## 2025.01.20: TRB140 Hardware Changes

PCN Number: PCN\_TRB140\_PHY\_SMA\_USB\_2025.01.20\_EN

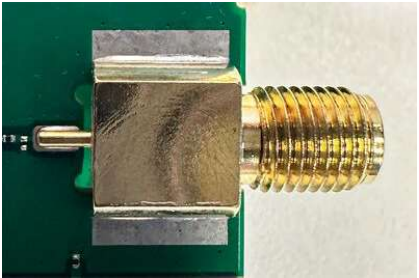
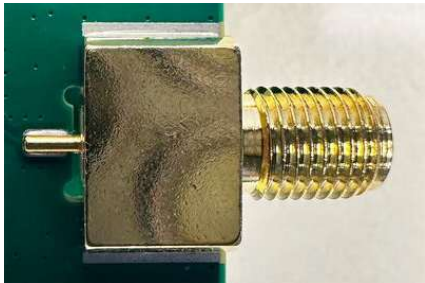
Change description		
Change type	Hardware changes	
Detailed description	<p>1. Starting January 2025, all TRB140 devices will be manufactured with a new PHY chip. They will require <a href="#">firmware version 7.06.07</a> or newer. Downgrading to earlier firmware versions will no longer be supported.</p> <p>2. TRB140 devices will feature updated RP-SMA and SMA connectors. These updates will not affect connector functionality but will enhance their form and manufacturability.</p> <p>3. The USB connector on TRB140 devices will be moved slightly outward to improve usability and cable compatibility.</p> <p>During a 3-month transition period starting in January 2025, shipments may contain either the current or updated design.</p>	
	Current design:	Updated design:
